Product Change Notice (PCN)

PCN Number: PCN-0374226R-01

- CPE 1785

❖ Appearance

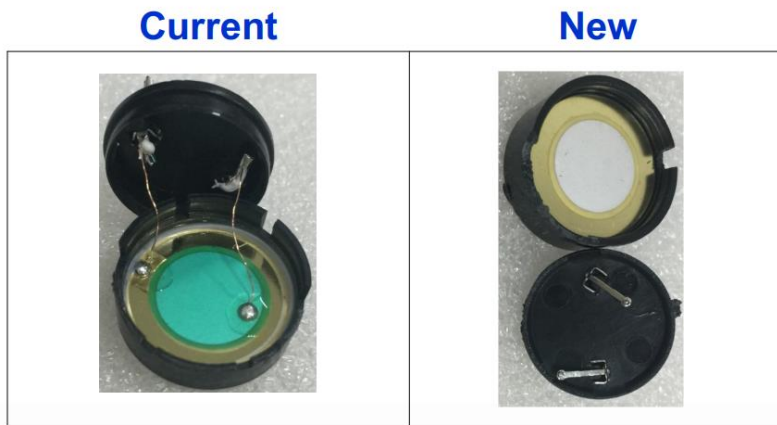
- Case markings Change from NORYL case to PBT
- Bottom notches going from 6 to 2

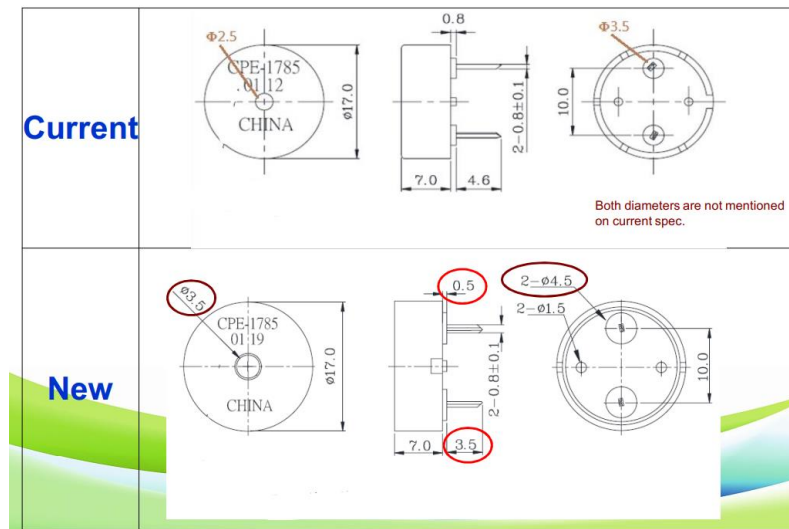
- ❖ **Inside structure**
 - **Change from solder mask on inside to spring contact**

- ❖ **Pin length from 4.6mm to 3.5mm**
